TRINITY METROSM

IFB-23-T026

ADDENDUM #3

THIS ADDENDUM IS ISSUED TO: Revised Plans based on Questions Received

SHEET
 C10.2

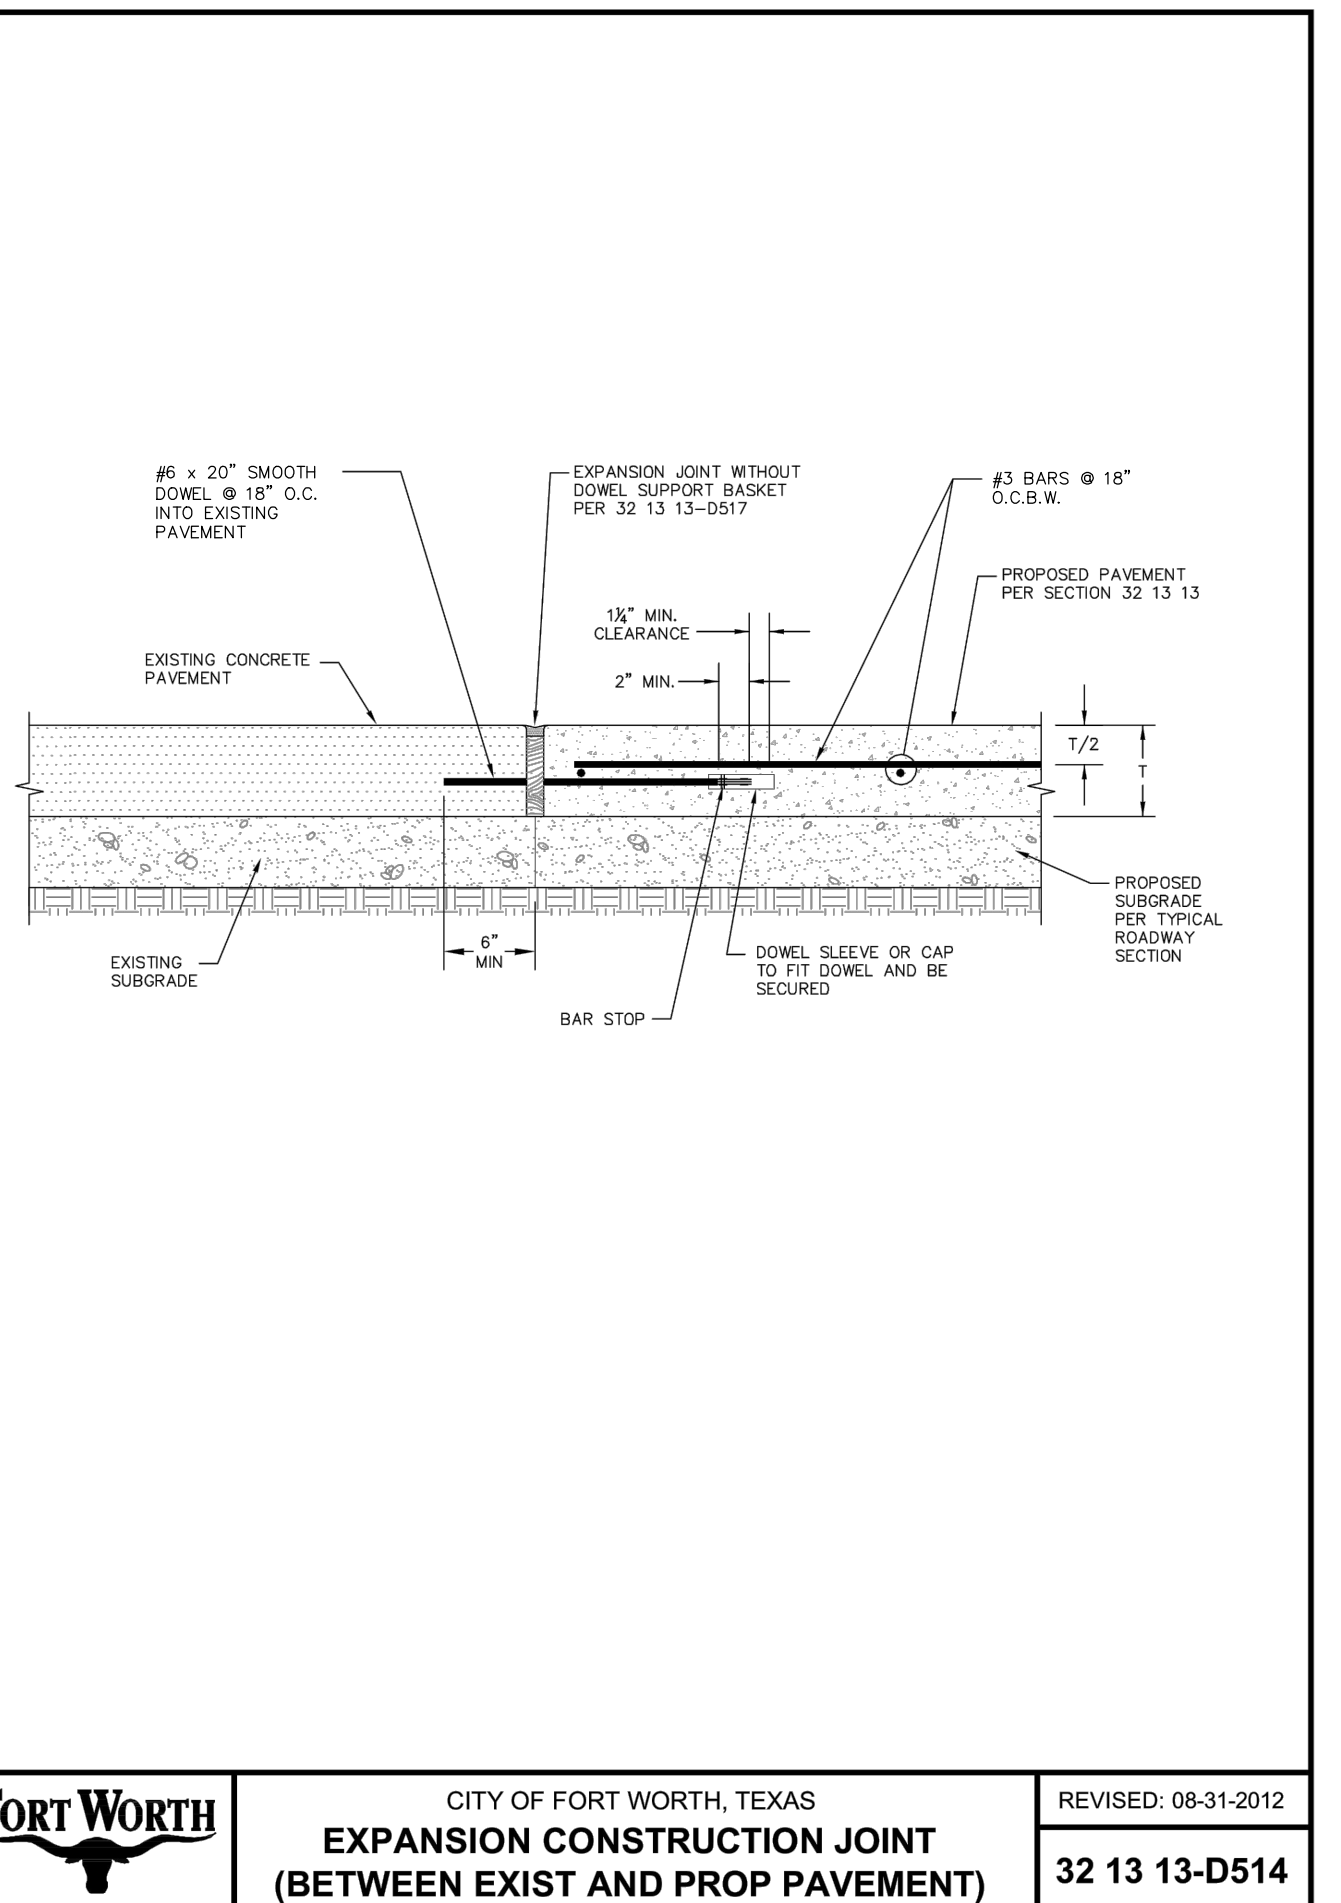
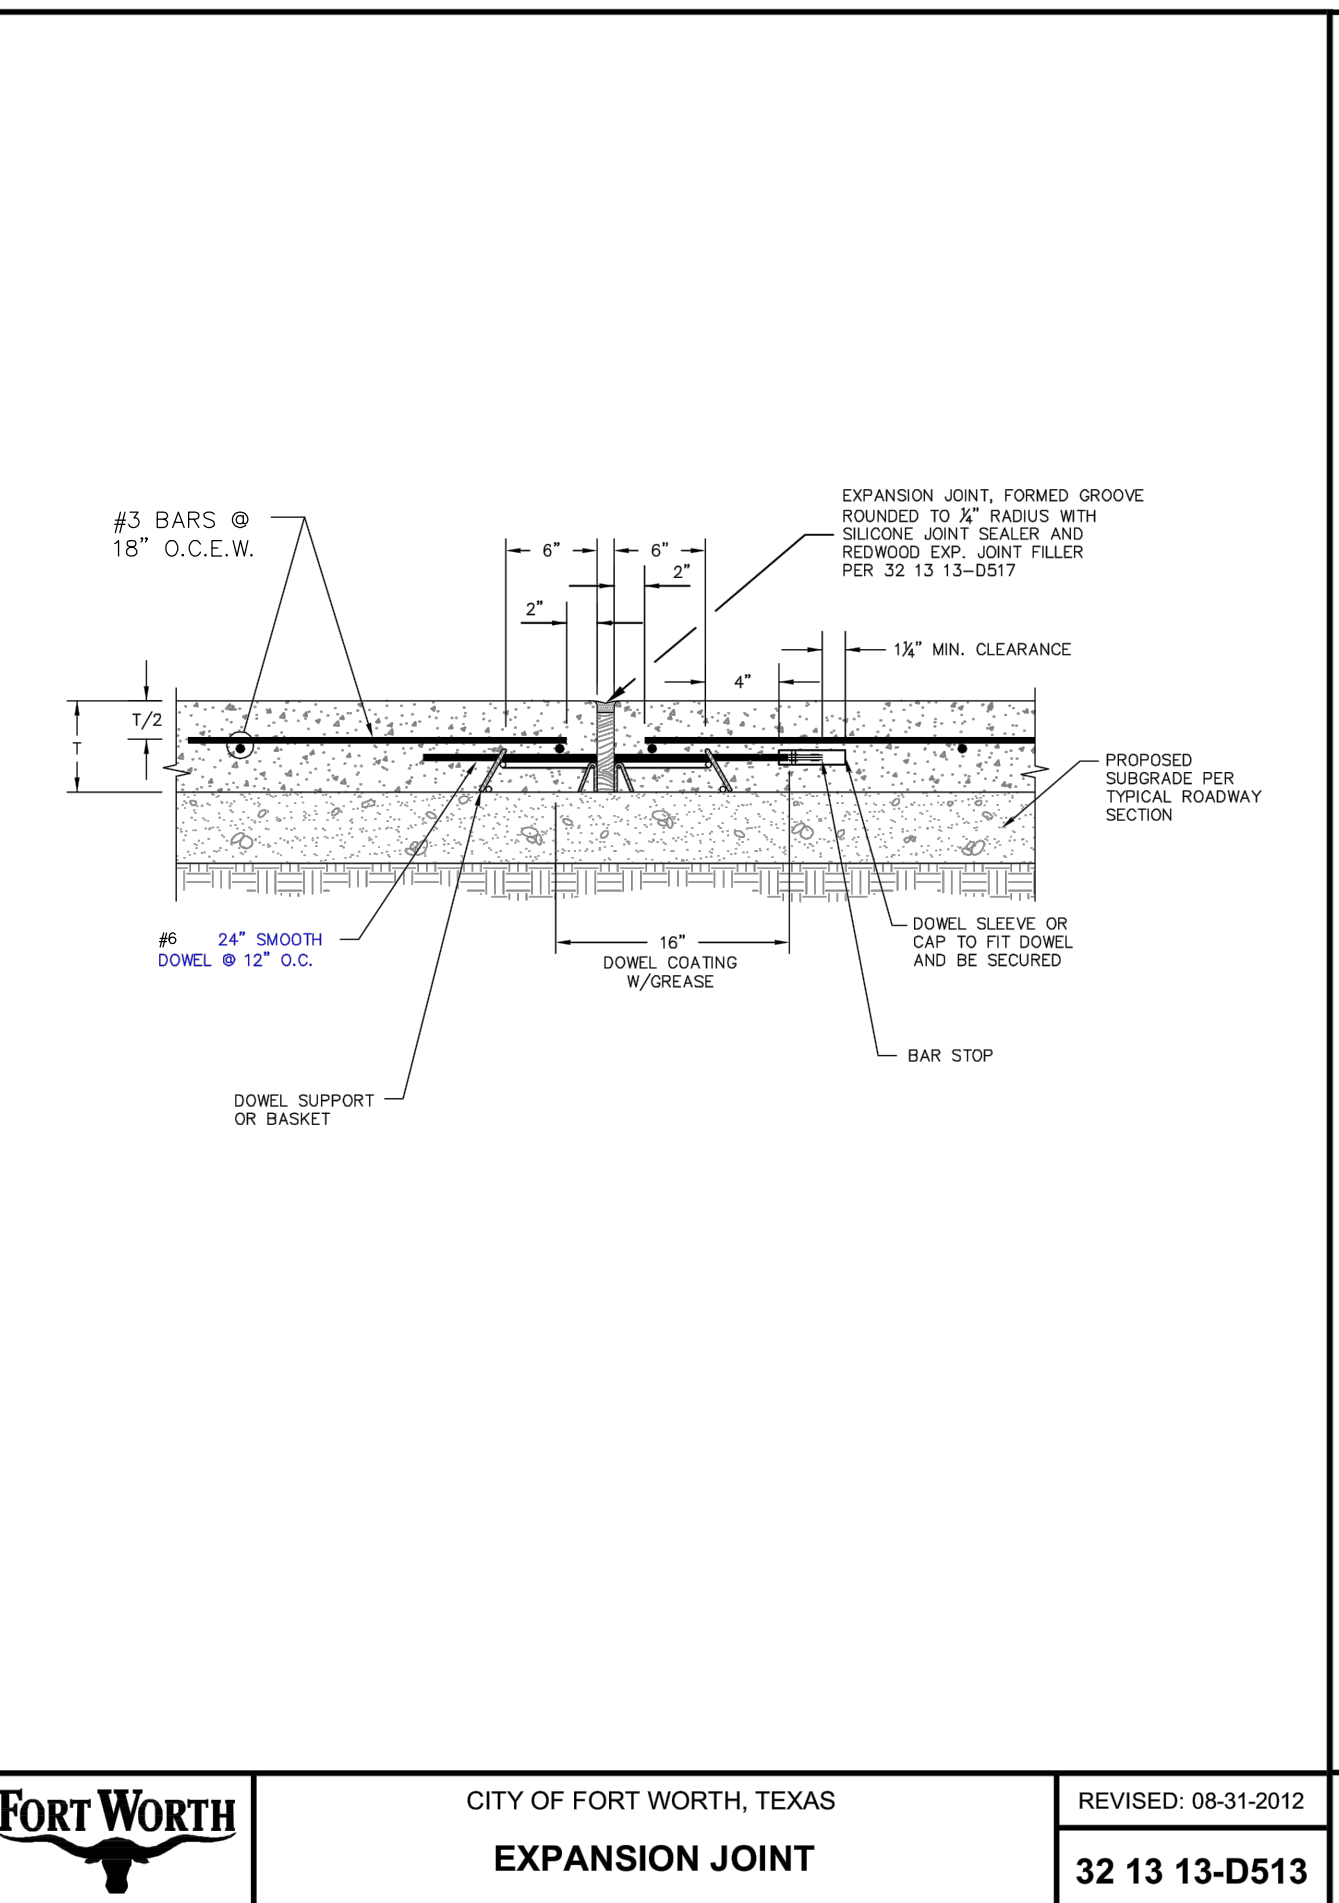
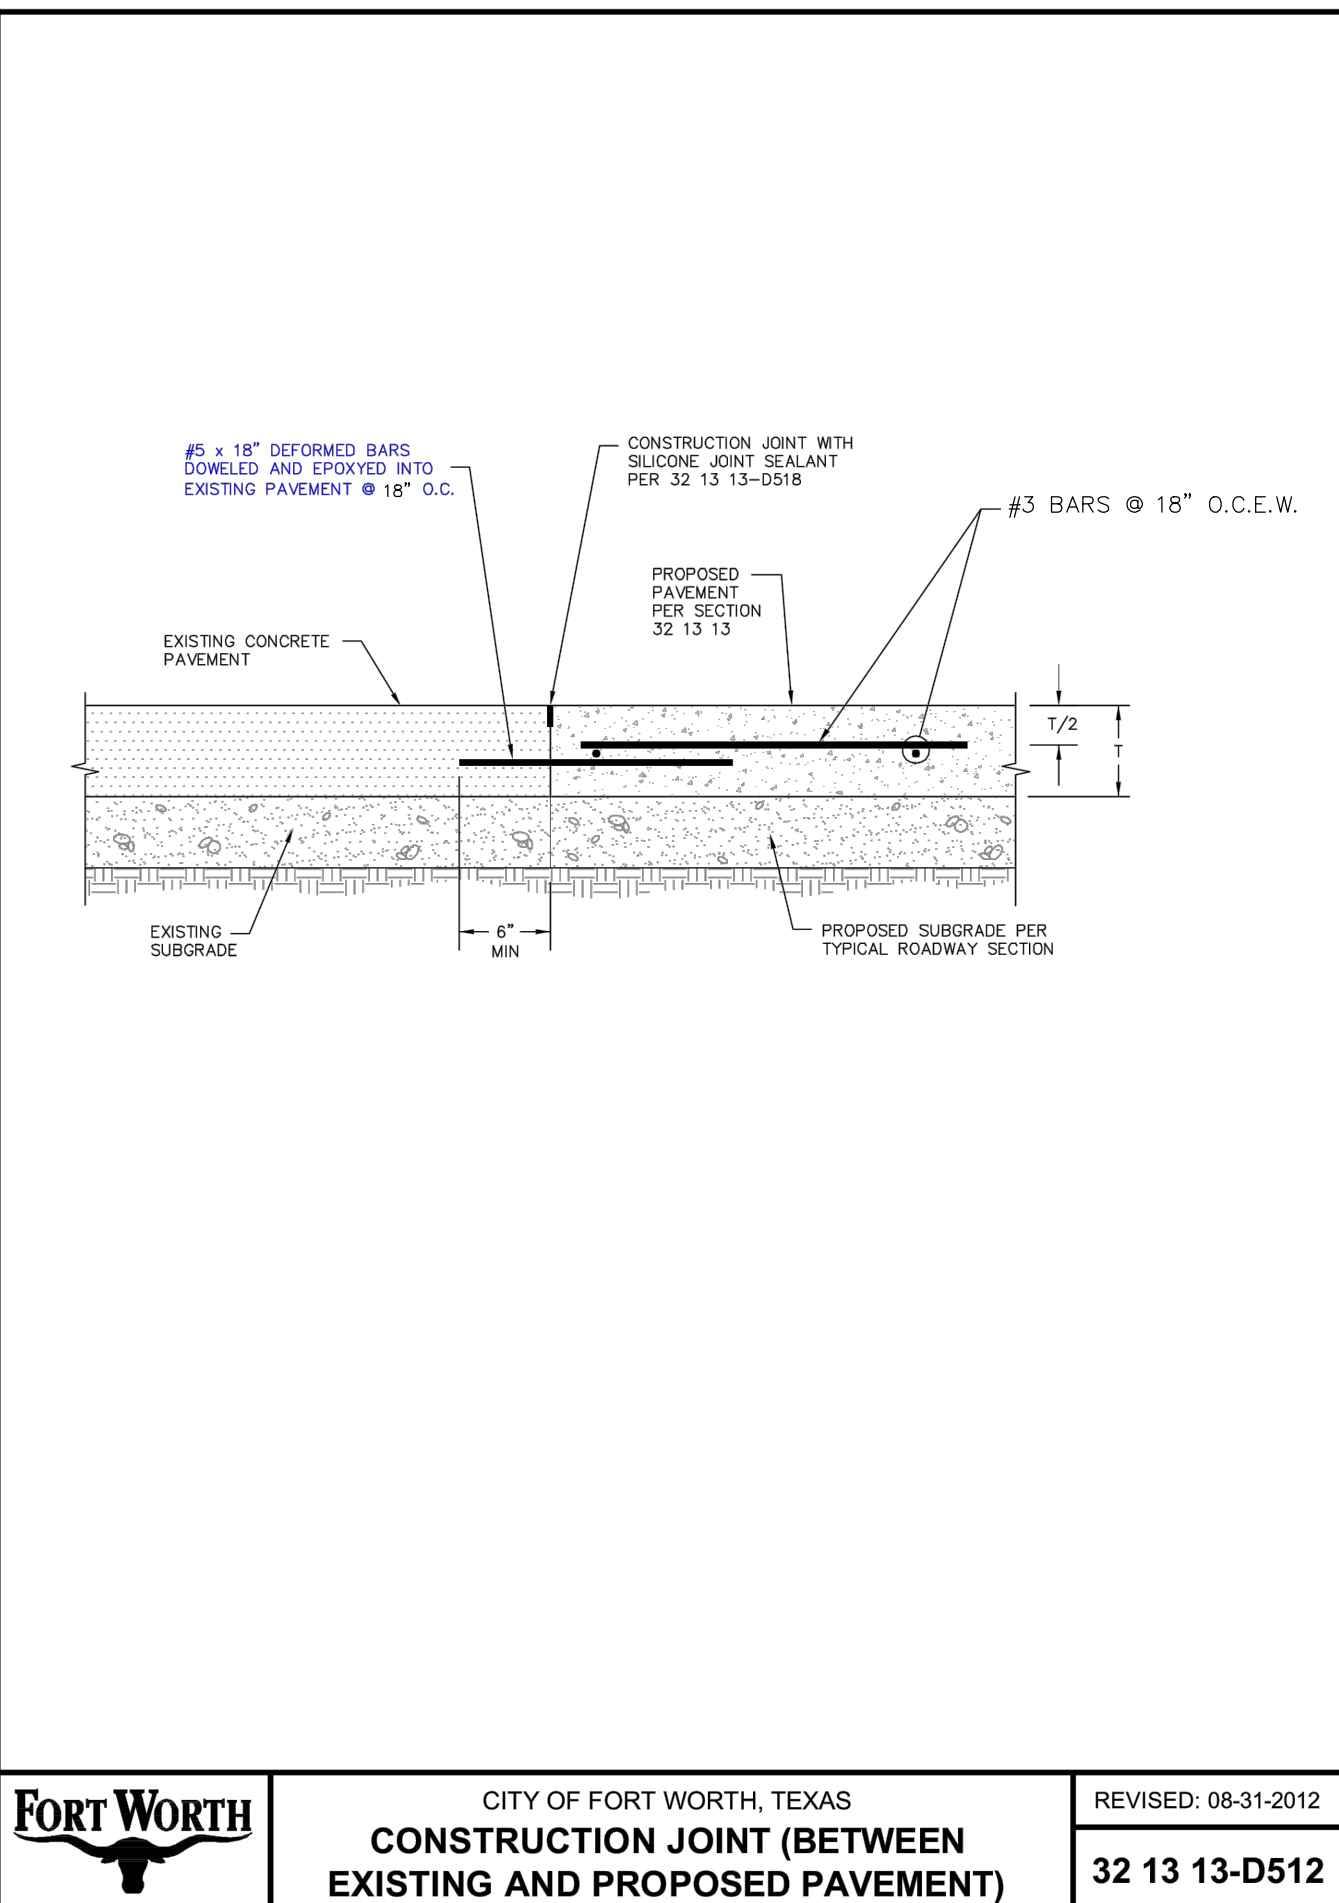
In addition, there are no details for the joints shown in the legend on the paving plans. Please provide details each type of joint.

Revised Drawings C6.1, C6.2 & C6.3, C10.2 & C10.3 are attached.
